MIL-S-19500/321A
AMENDMENT 5
28 May 1994
SUPERSEDING
AMENDMENT 4
30 June 1992

MILITARY SPECIFICATION

SEMICONDUCTOR DEVICE, DIODE, SILICON, MIXER
TYPES 1N21WG, 1N21WGM, AND 1N21WGMR

FIGURE 1. Semiconductor device, diode, type 1N21WG, 1N21WGM, 1N21WGMR.

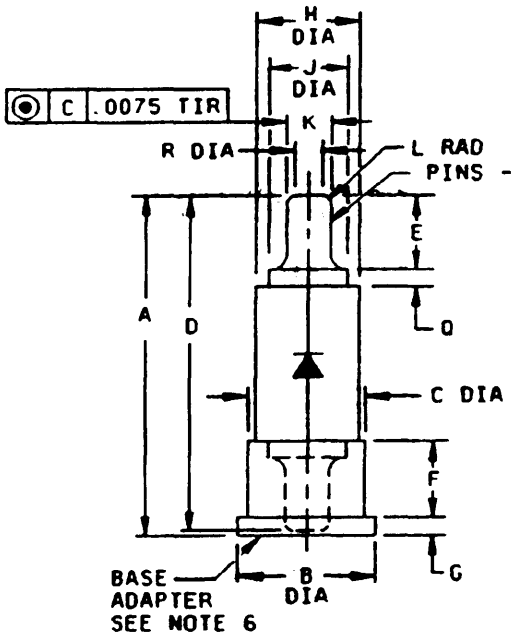
Replacement page	Page replaced
3	3
4	4
